2 D2.3 (#111, #131, #181, #322, #214, #333, #369).

14 Suggested Remedy:

20 145.2.8.5.1 PSE PI pair-to-pair effective resistance and current unbalance

32 **Figure 145-22—PSE PI unbalance specification and E2EP2PUnb**

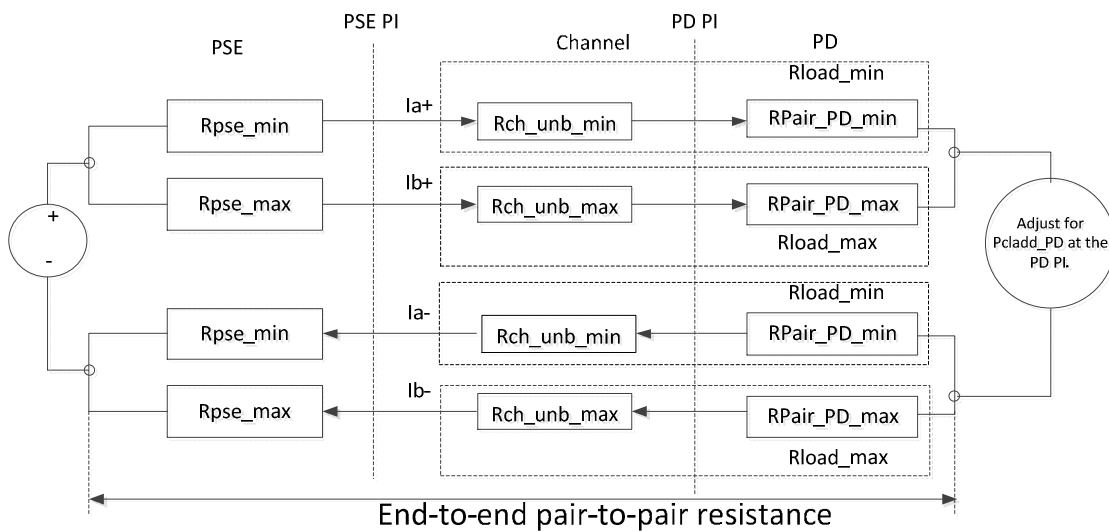
Figure 145-22 illustrates the relationship between RPSE_max and RPSE_min effective resistances at the PSE PI as specified by Equation 145-15 and the rest of the end to end pair to pair effective resistance components.

17
 18 Figure 145-22 shows a verification circuit for the current unbalance requirements measurement.

20
 21 ICon-2P-unb and Equation (145-15) are specified for total channel common mode pair resistance RChan-2P
 22 from 0.2 Ω to 12.5 Ω and worst case unbalance contribution by a PD. PSEs that support channel common
 23 mode resistance less than 0.2 Ω, or if RChan is less than 0.1 Ω, the PSE should meet ICon-2P-unb
 24 requirements when connected to (Rload_min - 0.5 × RChan-2P) and (Rload_max - 0.5 × RChan-2P). This
 25 can be achieved by using a lower RPSE_max or higher RPSE_min than required by Equation (145-15).
 26 Lower RPSE_max values may be obtained by using smaller constant α or higher RPSE_min in Equation
 27 (145-15) in the form of ~~RPSE_max~~ RPSE_max = α × RPSE_min + β.

39 **Figure 145A-2** – Common mode Pair-to-pair channel resistance unbalance

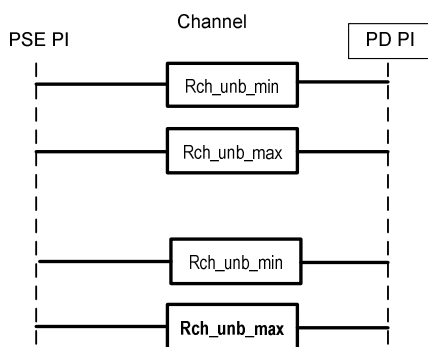
30
 31 Channel ~~C~~common mode resistance is the resistance of the two conductors ~~wires in a pair~~ (including
 32 connectors) in a pair, connected in parallel.

33
 34 The resistance of the common mode pairs of conductors and connectors Rch_unb_min and Rch_unb_max are
 35 described by Figure 145A-2.

41 Note: Each conductor in Figure 145A-2 is the equivalent of two conductors in parallel.

Figure 145A-1—Direct measurements of effective RPSE_max and RPSE_min

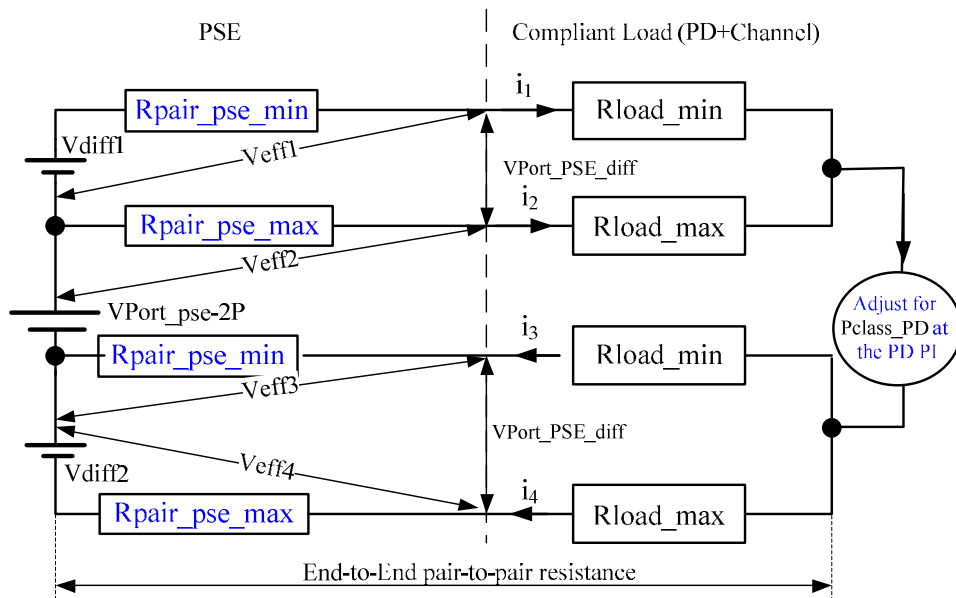
35 **Update Figure 145A-1as follows:**

36 **Change Rpair_{min} to Rpair_pse_min**

37 **Change Rpair_{max} to Rpair_pse_max**

Figure 145-34— I_{Con-2P} and $I_{Con-2P-unb}$ evaluation model

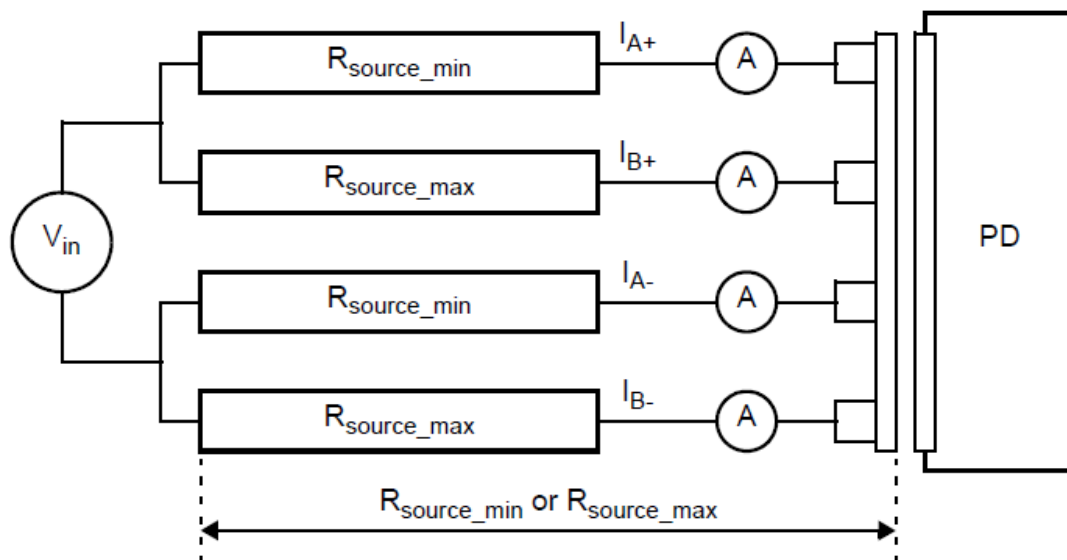
21 [\[Note 1 was changed to address comment #322. Note 2 cannot be changed\]](#)

22 NOTE 1—Rsource in Figure 145-34 includes [the connecting hardware resistance](#) ~~resistance~~ ~~Reon~~ ~~of~~
 23 [the evaluation model to the PD](#) which ~~its~~ ~~is~~ ~~the~~ ~~connection~~ ~~resistance~~ ~~at~~ ~~the~~ ~~PD~~. The maximum
 24 recommended [value](#) ~~is~~ ~~Reon~~ ~~value~~ is 0.02 Ω .

Figure 145X-1—PD resistance unbalance elements overview

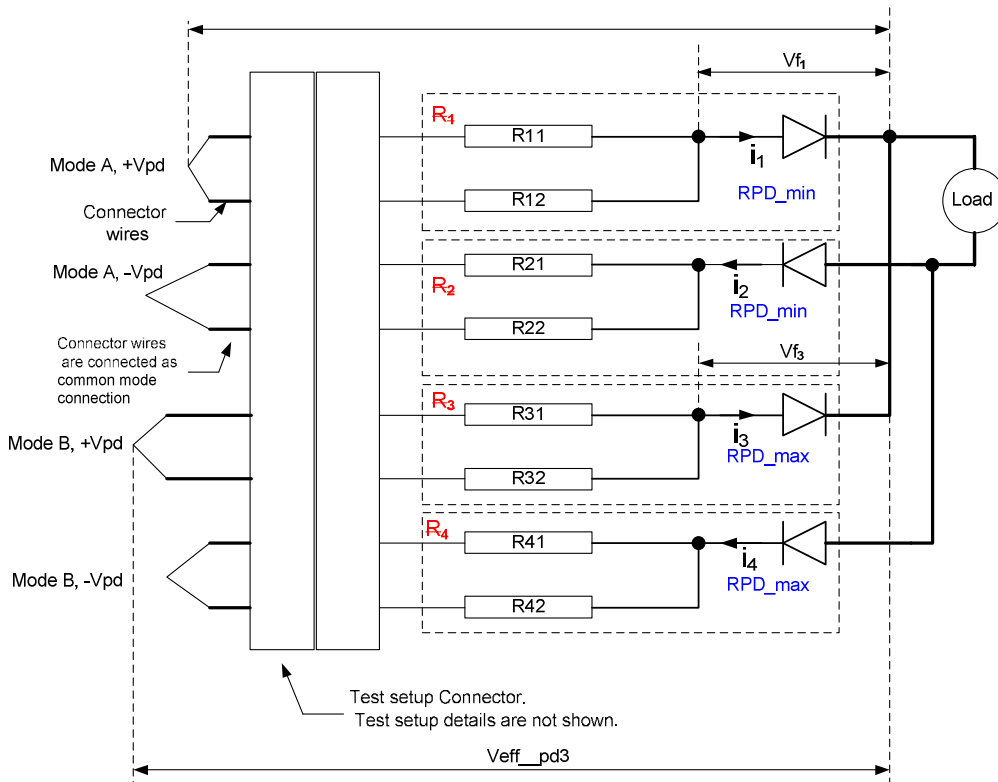
-The following is darshan_05_0116Rev005.pdf with new updates for D2.3 regarding using RPD_min/max instead of Rpair_PD_min/max in the text and in the drawings.

- Copy the following text and drawing into Annex 145X (used to be Annex 33A.5 in D2.2).
- Approved Changes in Figure 145X-1 from D2.2 to D2.3 are marked with RED color.
- New Changes in Figure 145X-1 from D2.3 to next draft are marked with BLUE color.
